## NEW PTO SERIES 23Z4 FOR IVECO 2840.6 FL2011 GEARBOX

### TECHNICAL SPECIFICATIONS PTO SERIES 23Z4

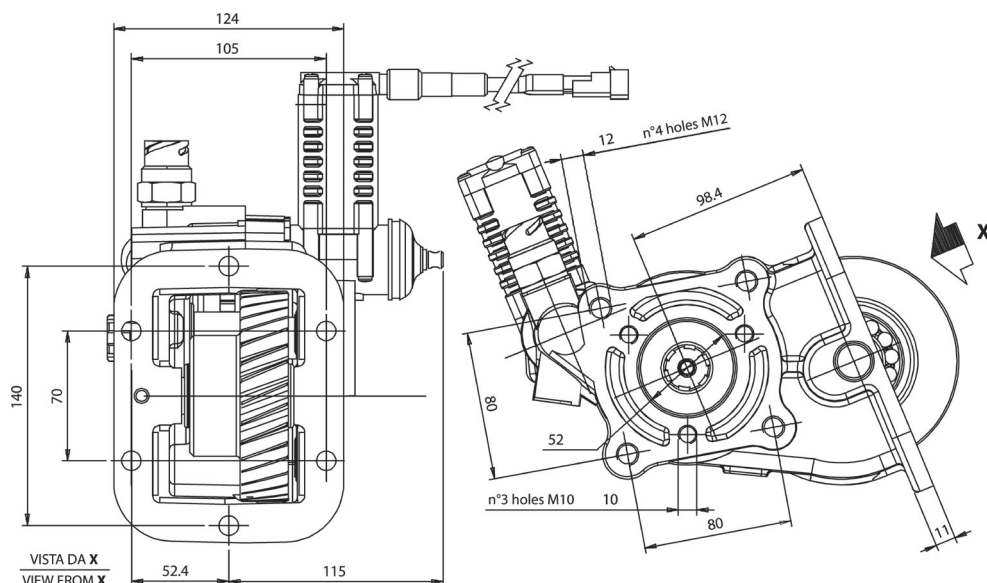
Starting in June 2011, IVECO will be equipping its Daily vehicles with the new 2840.6 FL2011 gearbox. These new gearboxes differ from the old 2840.6 ones by the "Part Number" shown on the gearbox plate which must be 8873021 or 8873022.

HYDROCAR has the PTO suitable for this type of gearbox: series 23Z4.

Internal ratio:	1:1,3
Torque (Nm):	180
Low speed:	1080
Rotation:	opposite
Shift type:	Electric KES 5 Mechanical for TXZ Pneumatic 1/8" GAS
Require:	Mounting kit code 199K8100000
On request:	MERIT switch kit code 194KSP17000 TDS switch kit code 194KSP28000
